P1775 text: 7.2.2.3.1 AC ports (conducted emissions) - The test setup and procedures in CISPR 16-2-3 and ANSI C63.4 shall be used. **The transmit BPL function shall be disabled unless national regulation specify that conducted limits apply to the carrier current emissions.**

P1775 text: Balloter comment on Figure 9.

Figure 9 -- Example of geometry for measurements at 8 positions (45°) around the perimeter of an in-ground power transformer

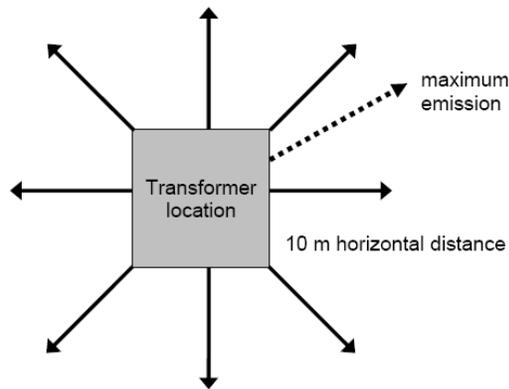
Balloter Comment: Figure 9 shows that 8 compass points around the radiating transformer should be tested. This is not in harmonization with the requirements of ANSI C63.4, a normative reference to the standard. C63.4 requires that 16 cardinal points be measured. It is also not in self harmonization with Clause 7.2.1, which requires 16 points around a building carrying a BPL signal.

Balloter's proposed resolution: Change figure and text to show 16 compass points, in compliance with C63.4.

P1775 proposed/approved rebuttal: Extensive testing experience indicates that field strength around an underground installation can be generally characterized with fewer than 16 points. The draft provides for additional measurements to identify the maximum emission. Experience indicates that a similar simplification does not apply to measurements around dwellings.

Discussion: The requirements in C63.4 to test 16 radial points is based on decades of experience over a wide range of DUTs. The premise that this group, with no more expertise than having hired testing companies to make measurements, has a better body of knowledge about general testing requirements than the hundreds of people involved in C63 over decades is simply wrong.

SDCom proposed resolution: Change figure and text to show 16 compass points, in compliance with C63.4.

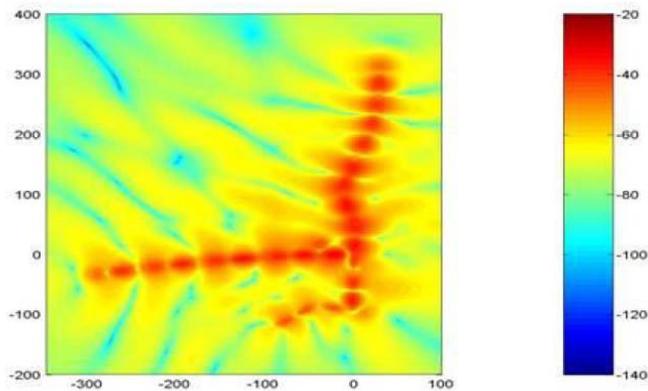
Discussion: Annex A is the most important parts of this document, especially with respect to technical accuracy. This procedure is being considered by the FCC for adoption into the rules, which will have probable world-wide implications and have ripples into FCC rules applying to other measurements and technologies. The issues dealing with extrapolation in the near field has been worked on by the EMC community for decades, and the premise that all we had to do was turn it over to the BPL industry is unsupportable. Following very vague references in CISPR 18, Annex A outlines how to make measurements of 4 points in situ and determine that “actual” extrapolation.

This methodology has not been demonstrated to be accurate in a complex EMC environment. As just two examples, note the graphs shown below. The first is a bird’s eye view of the H field from an overhead power line, from a method-of-moments calculation of an antenna model of an overhead line in Allentown, PA, developed by the NTIA. Note that the way that field strength varies with distance at different points along the line varies tremendously from point to point, even being different in most cases on one side of the line than it is on the other. The premise that 4 points can be measured in this environment to determine the “real” extrapolation is flawed.

SDCom proposed resolution: Delete Annex A from the standard pending more complete work to characterize how such measurements can be made reliably in the very complex in-situ environment near large radiators. To address the statements about what distance extrapolation factor should be used in the absence of national regulations, the Working Group should either develop and justify a conservative extrapolation factor or use the methods described in C63.12 or any of a number of other standards that specify that extrapolation within the wavelength / 2pi region shall be presumed to be 40- or 60-dB/decade (for H and E fields respectively) and 20 dB/decade beyond that region.

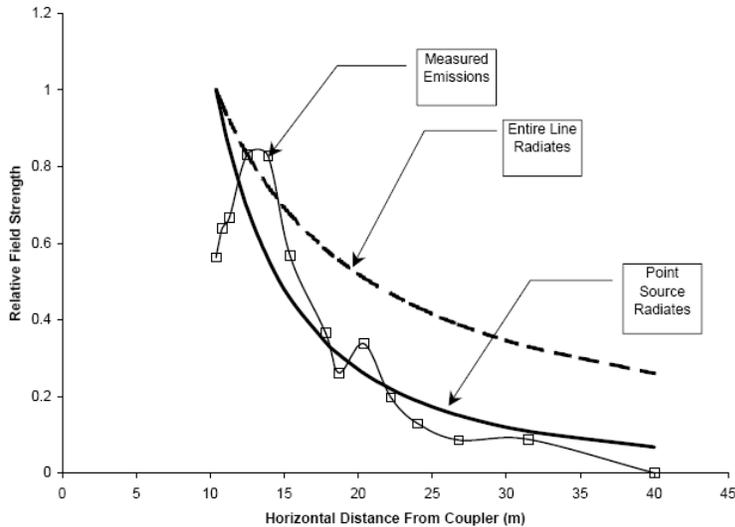
The second figure below is from a graph provided to the FCC by Current Technologies, one of the BPL manufacturers. It shows the measurements Current made of the field strength vs distance from an overhead power line. Note that one would obtain a different “real” value for extrapolation from any

four set of points chosen from these data. A standard based on such a wildly varying set of results is insufficient and premature.
